# TN CONSULTING PTY LTD

**RE: STAGE 3 OF THE CAMDEN GAS PROJECT – NORTHERN EXPANSION (09\_0048)**  
**Exhibition of Response to Submissions and Amended Development Application**

**Submission on behalf of landowners of Lot 3 DP 260703**  
**Properties: 188 Raby Road Catherine Fields**

## DRAFT LOCAL ENVIRONMENTAL PLAN NO. 151

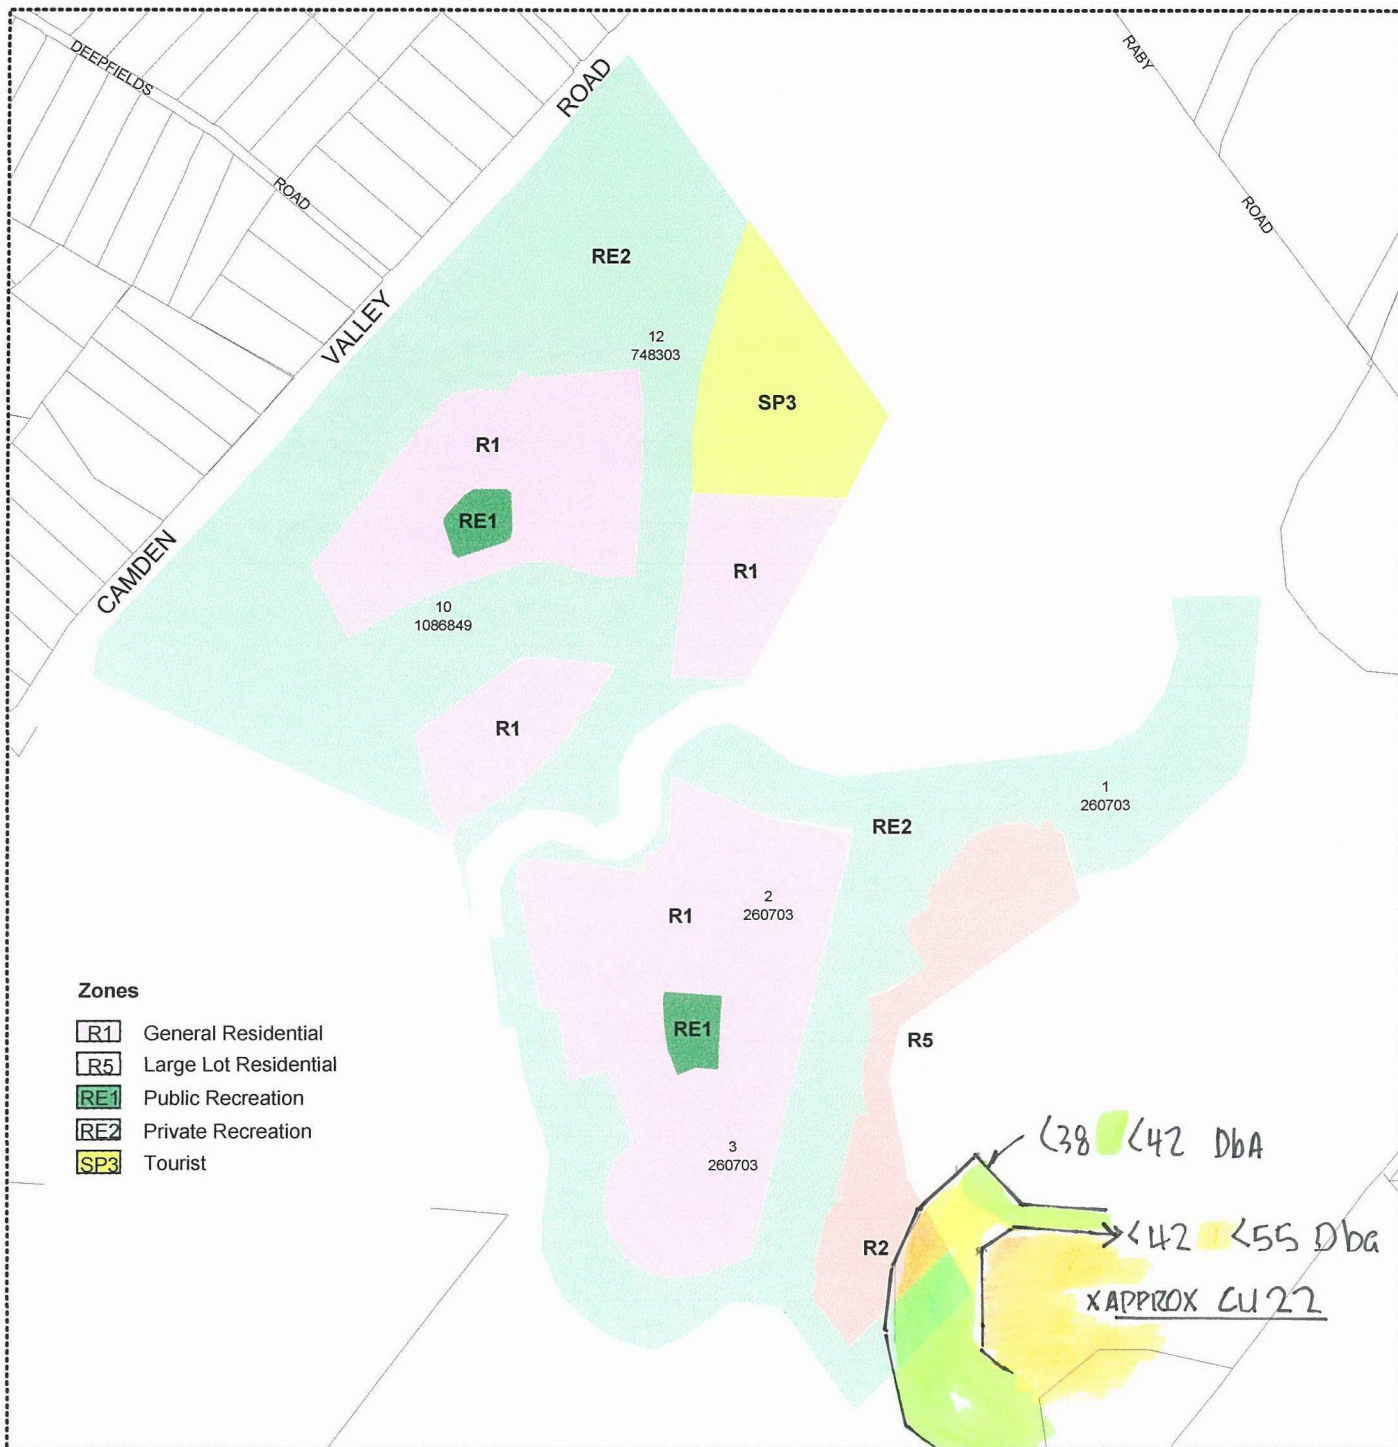
The subject Lands are part of the ECB / Gledswood / East Side proposed rezoning, known as Camden Council Draft LEP 151. Part of the lands are proposed to be zoned Private Recreation, Part of the lands are proposed to be zoned Residential Large Lots R5, Residential Low Density R 2 and General Residential R1. Under the Draft LEP 151 the lands have development potential for some 860 lots as shown on the attached Zoning plan. **(Attachment 1)**

**Figure 2 CU22 Operational Noise Predictions, Pump Assisted, Night-time Inversion**

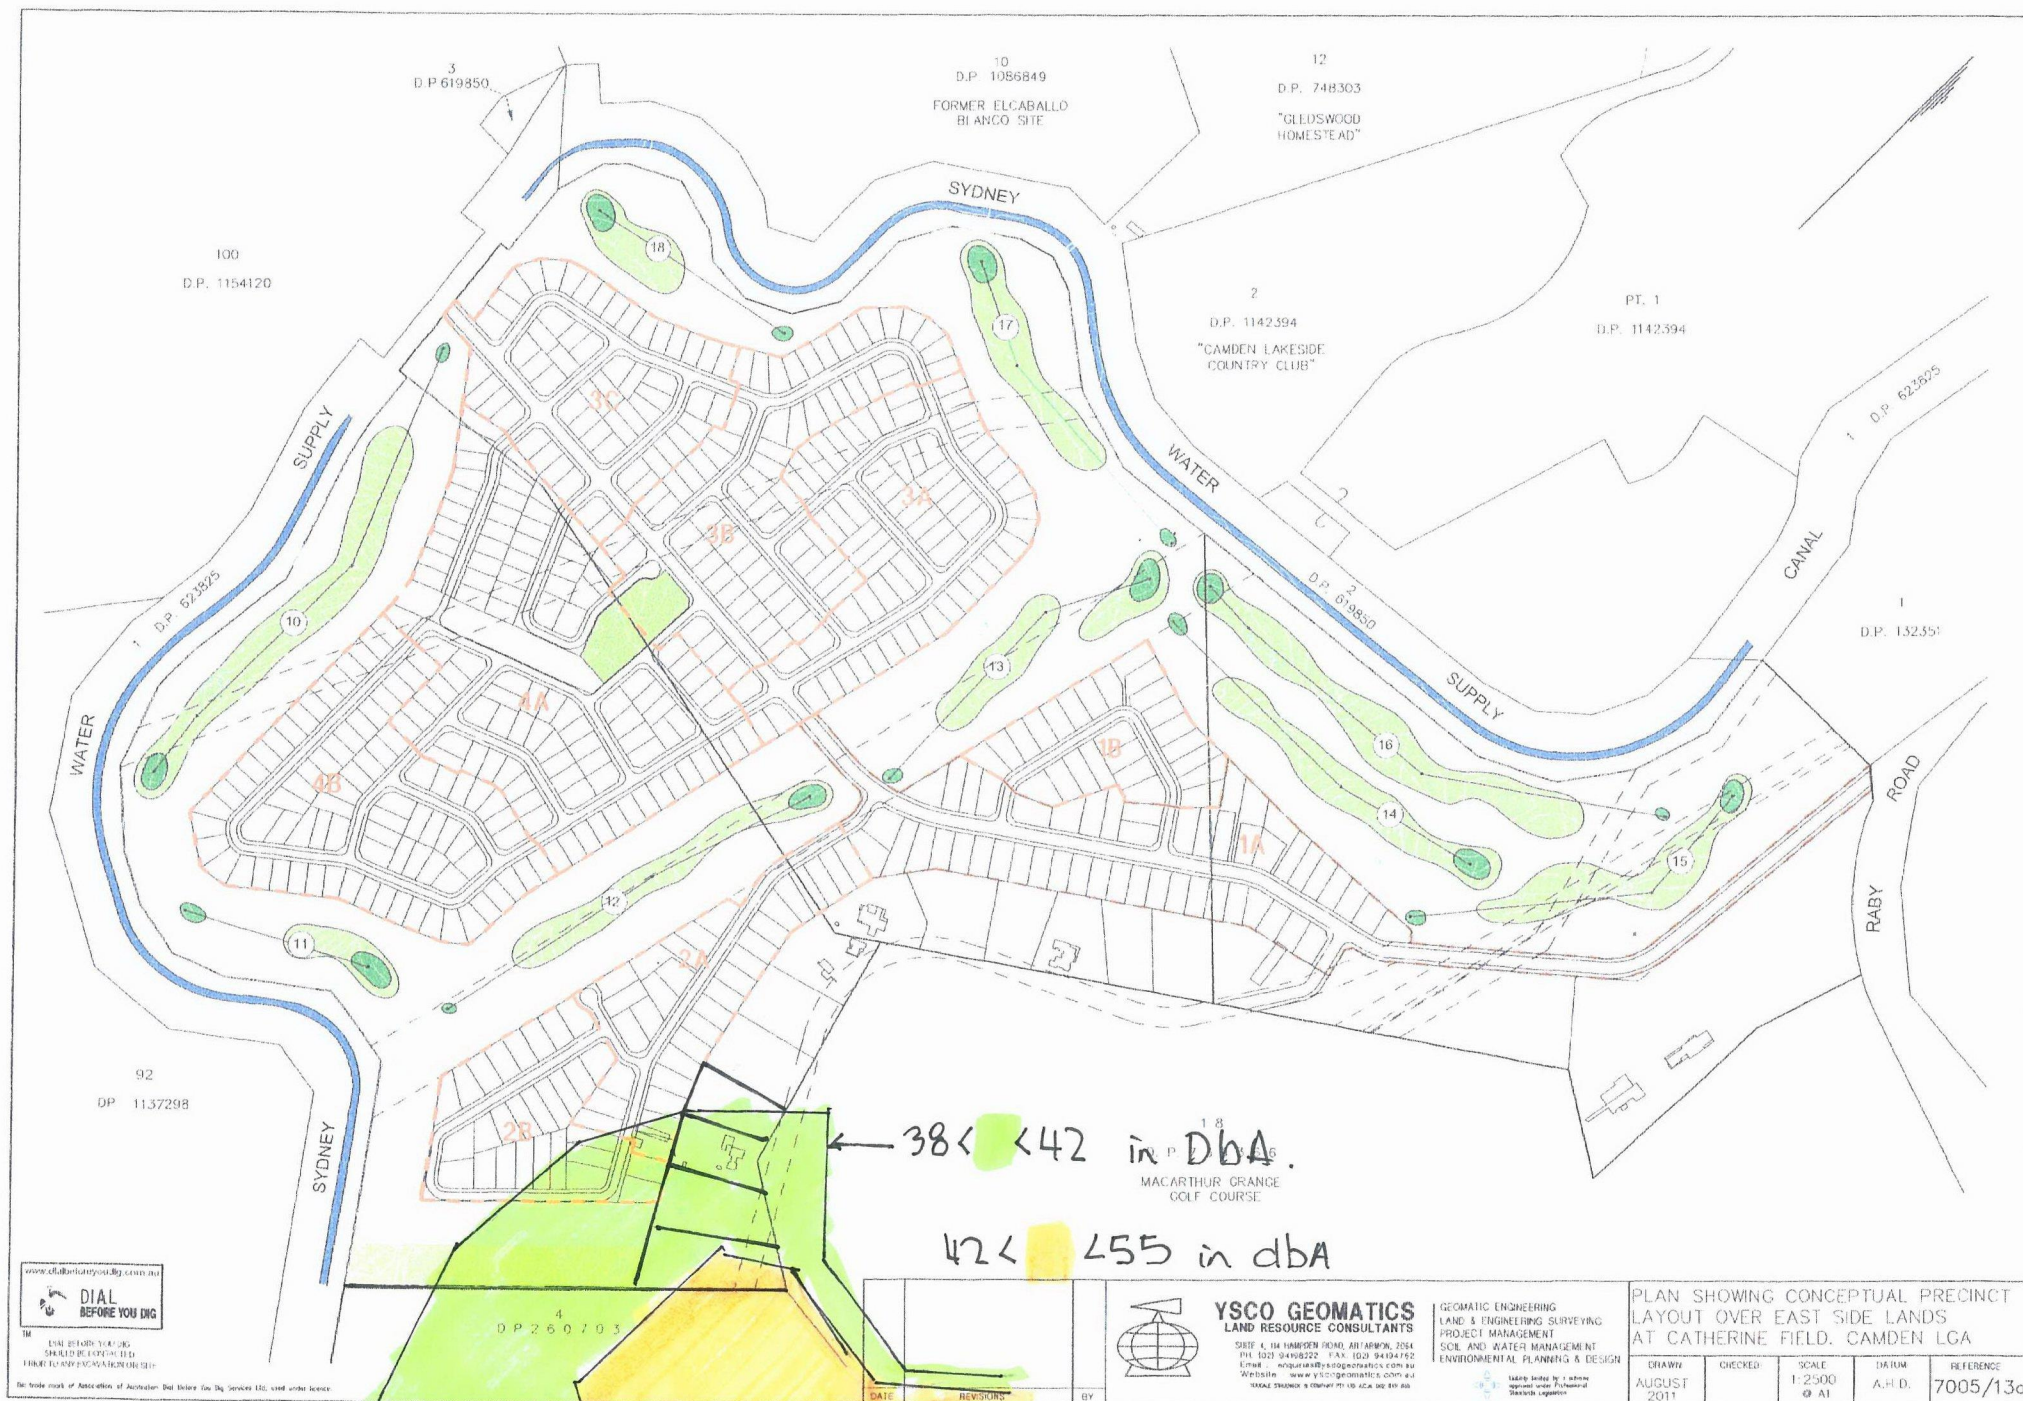
The Noise and Vibration Impact Assessment report, as amended, prepared by SLR Consulting provides operational and drilling noise predictions for the well location at CU 22. **(Attachment 2)**

The predicted operational noise levels relevant noise criteria are quoted as Leq (15min) 38 - 42 dba.

This level of operational noise will operate indefinitely, and will affect not only one existing residence at 188 Raby Road, but all future residences in the eastern end of the site.  
(Approx 15 new residences). **(Attachment 3)**

(Note: there are two proposed Large Lot residences to the east of the existing residence which will be affected; the most easterly residence will be within the Leq (15min) 42-55 dba, which is unacceptable.

The position of the CU 22 Gas Well must be relocated to not affect any existing or proposed residential zoned land, and it is further suggested the Well Sites to be relocated further to the north or further to the east of the proposed location, on the eastern slopes of the Scenic Hills within the Rural zoned land in Campbelltown LGA.
